USER NAME	mgarvide	DESIGNED	MG	REVISED	ADDENDUM 1 01/08/14
PLOT SCALE	1/8"=1'-0"	DRAWN	MG	REVISED	-
PLOT DATE	08-JAN-2014 15:54	CHECKED	KGP	REVISED	-
		DATE	10/25/2013	REVISED	-

TEMPORARY CABLE PLAN, TEMPORARY PHASE DESIGNATION DIAGRAM,  
AND TEMPORARY EMERGENCY VEHICLE PREEMPTION SEQUENCE OF OPERATION  
ILLINOIS ROUTE 64 (NORTH AVENUE) AT VILLA AVENUE  
SCALE: AS NOTED SHEET NO. 11 OF 26 SHEETS STA. TO STA.

F.A.P. RTE.	SECTION	COUNTY	TOTAL SHEETS	SHEET NO.
307	131B-BR	DUPAGE	111	54
CONTRACT NO. 60V24			ILLINOIS FED. AID PROJECT

**CABLE PLAN**  
(NOT TO SCALE)

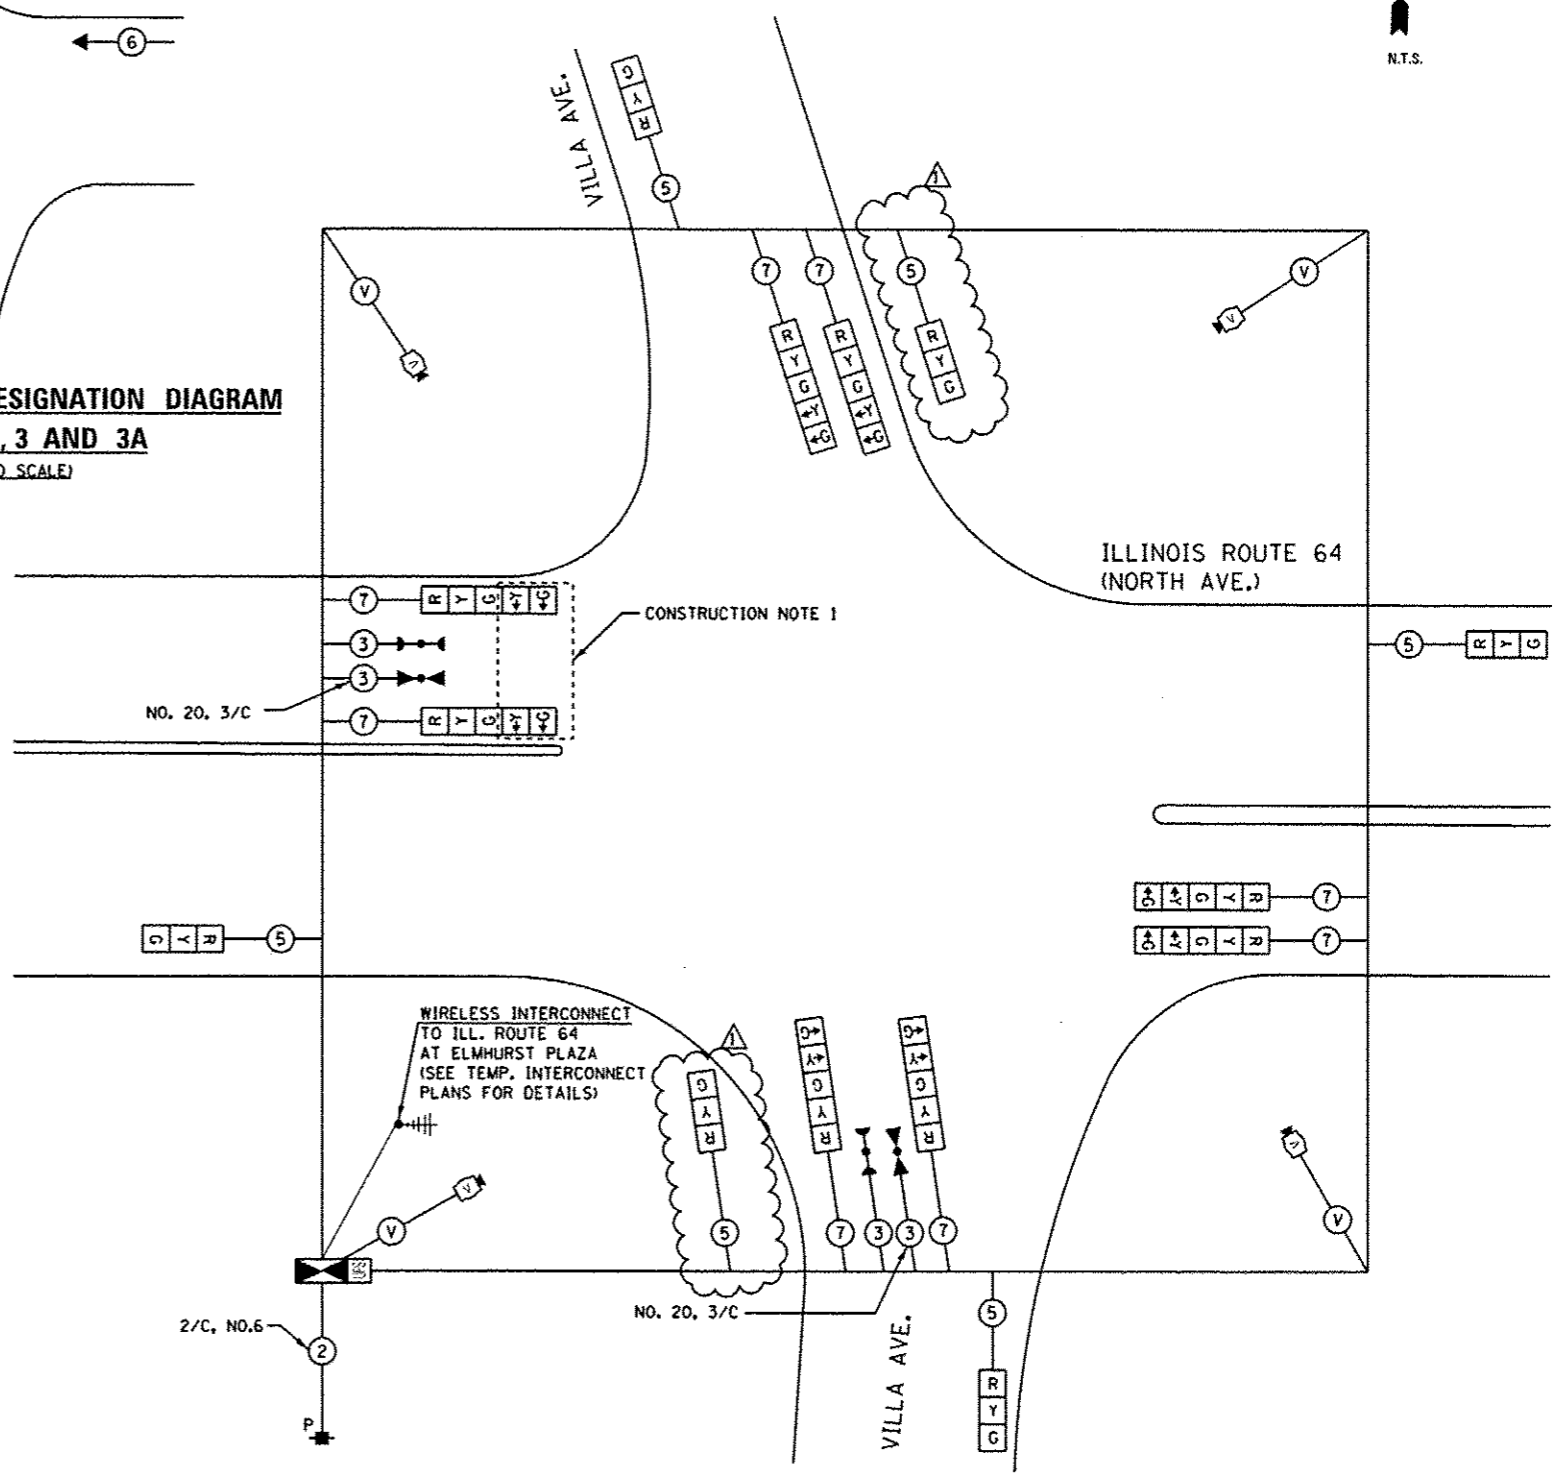
- THE YELLOW ARROW AND GREEN ARROW INDICATION ON THE 5-SECTION SIGNAL HEAD FOR THE WESTBOUND DIRECTION SHALL BE USED ONLY DURING PRE-CONSTRUCTION AND INTERIM STAGES AND SHALL BE BAGGED AND DISCONNECTED AT THE CONTROLLER DURING CONSTRUCTION STAGES 1, 2, 3 AND 3A.
